WINDOW & ENTRANCE REPLACEMENT

**JANE RYAN ELEMENTARY SCHOOL
190 PARK LANE
TRUMBULL, CT 06611
STATE PROJECT #144-0104 EC/CV
RFP #6300**

S/P+A PROJECT NO. 18.031

DATE: August 3, 2018

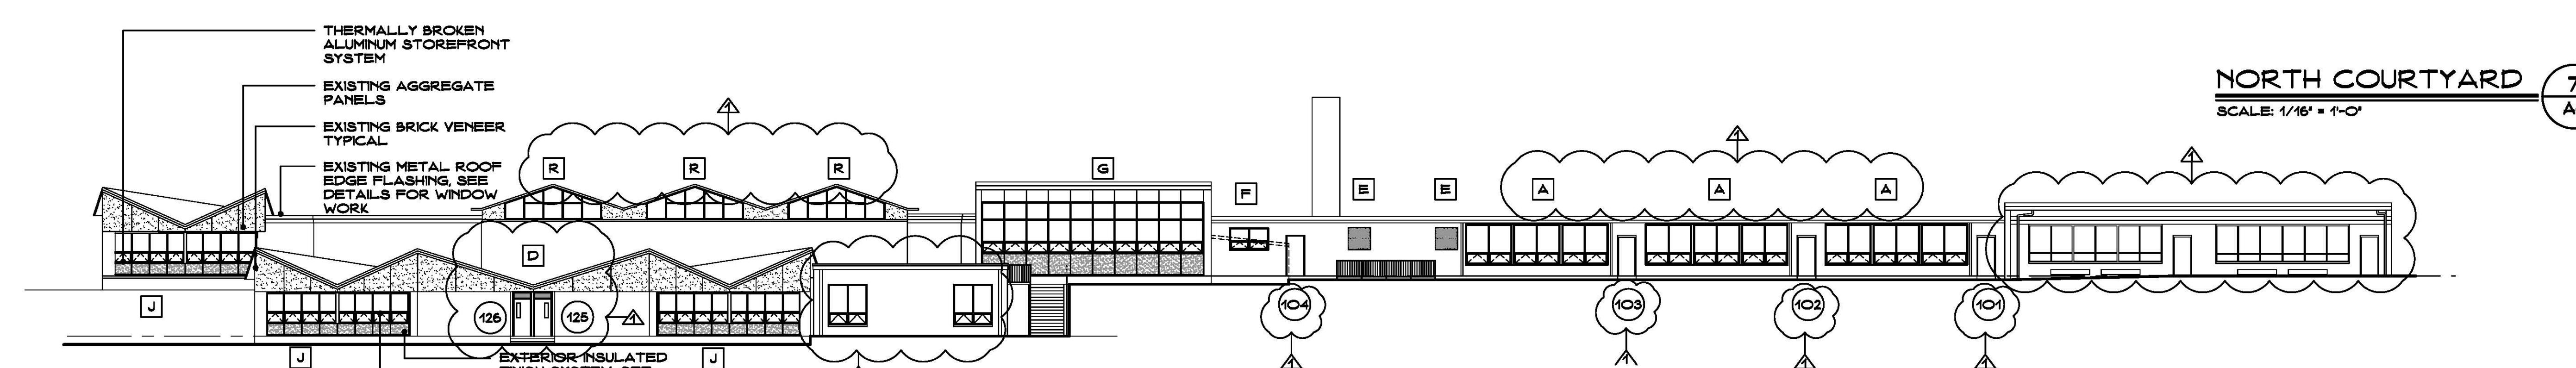
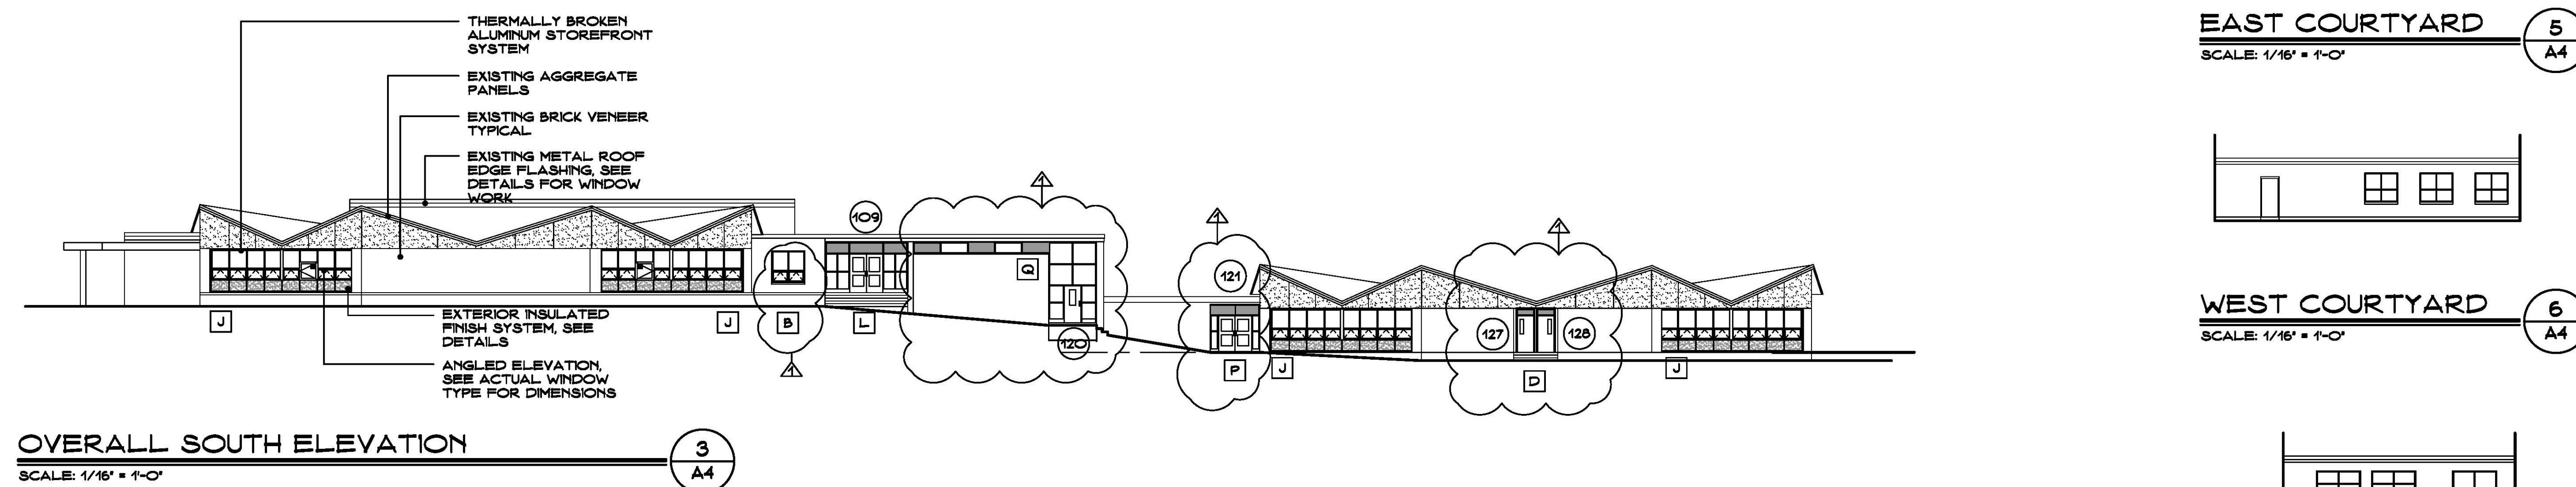
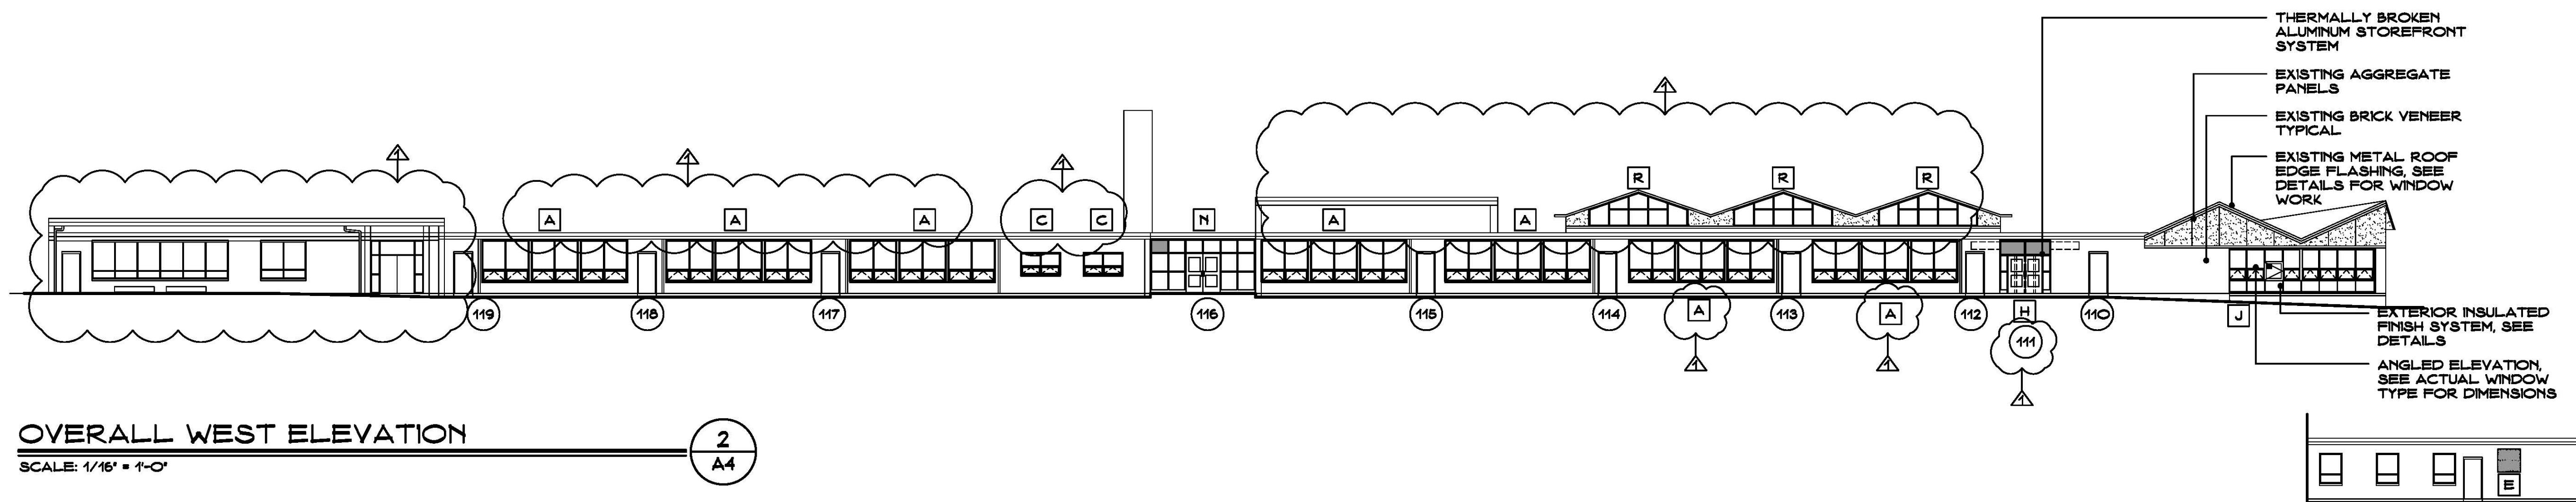
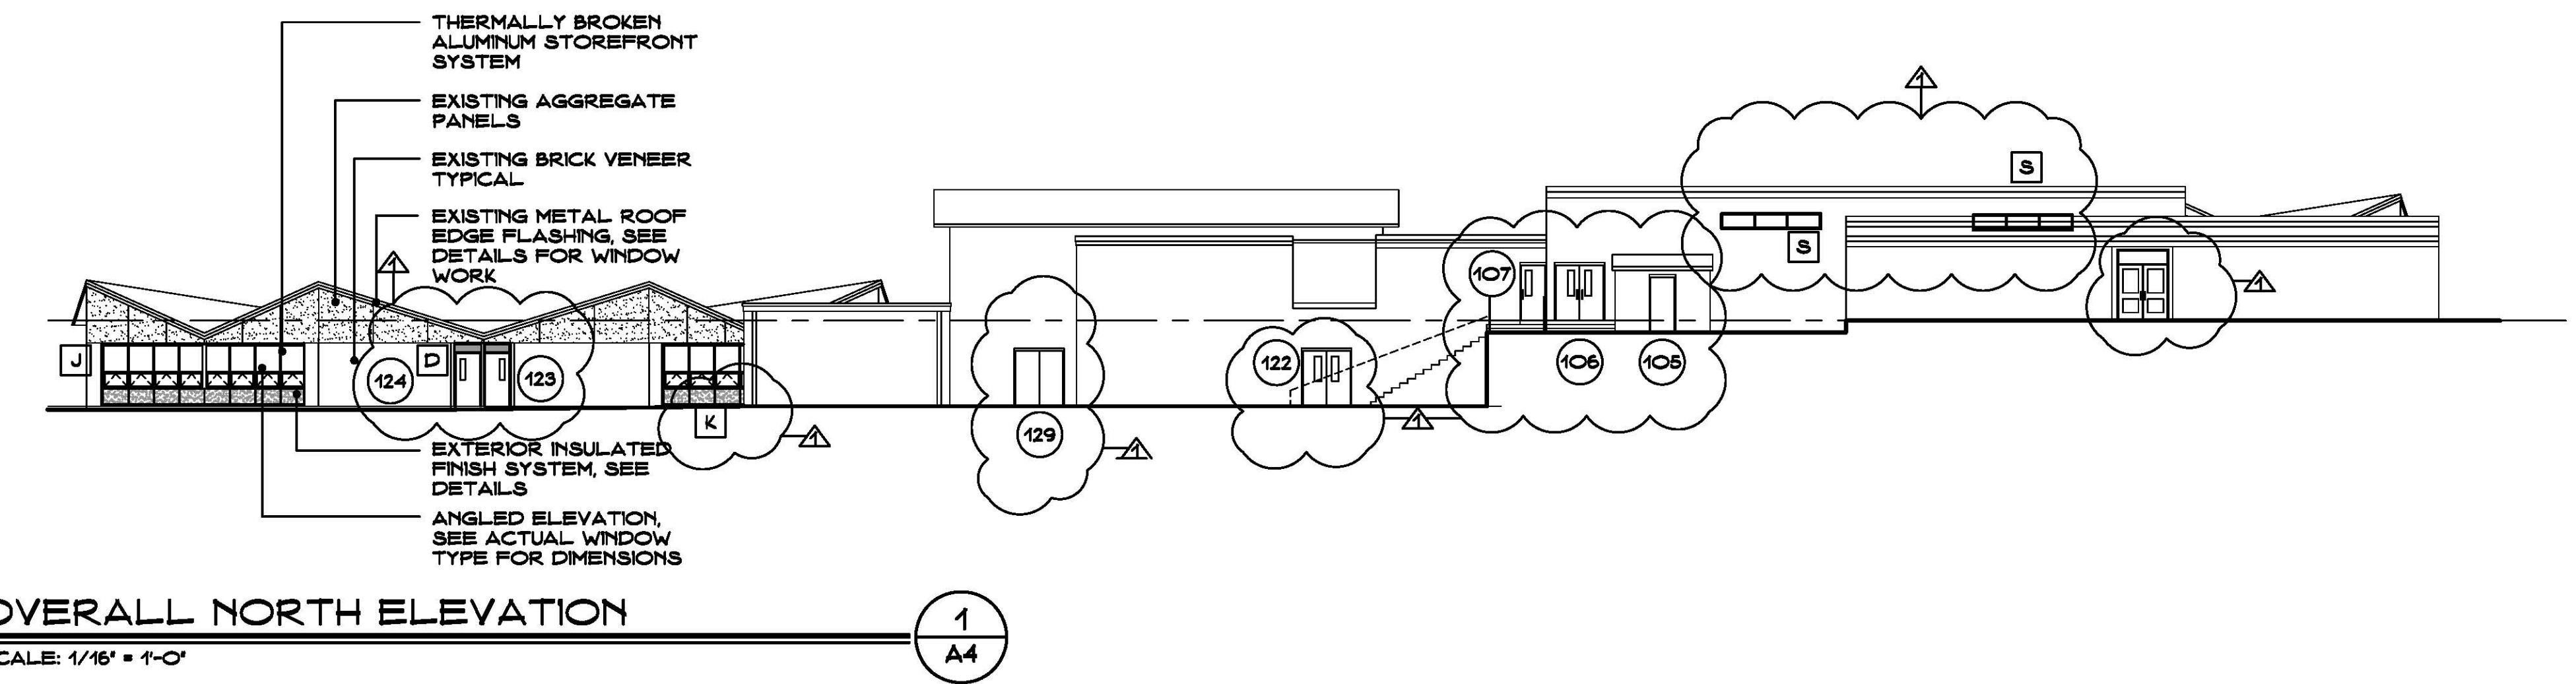
Q6: The floor plan and the elevations have different labels for the windows, what is correct the floor plan or the elevation?
A6: Refer to the revised Drawing A4 included within this addendum.

Q7: The floor plan and elevations indicate more doors than the door schedule show, what is correct?
A7: Refer to the revised Drawing A4 included within this addendum.

“Window Blinds:
-Reinstall on new wood trim. Provide Add Alternate for new blinds. See proj. man.” *(Per Owner/RFI Q8)*
- DRAWING A4, EXTERIOR ELEVATIONS has been deleted in its entirety. A new DRAWING A4 has been added and is attached as part of this addendum.* *(Per RFI Q6)*
- DRAWING A9, SCHEDULES & DETAILS, Door Schedule, Door 129, Door Type, revise “3” to read “1”. *(Per RFI Q6)*
